Product Change Notice (PCN)

PCN Number: PCN-0381408R-01

Product(s) Affected: CMS-160916-30-3

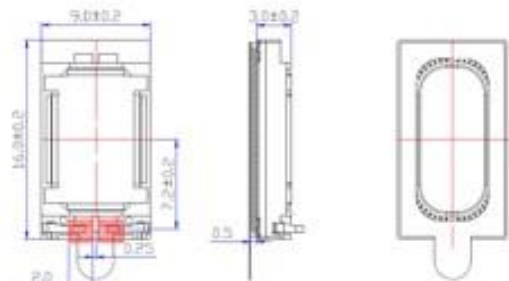
Description of Change: *Power rating change to 0.8W rated; sound pressure level change to 88dB @ 0.8/10cm; resonant frequency change to 600Hz; THD change to 15% max; multiple housing/appearance modifications as shown below:*
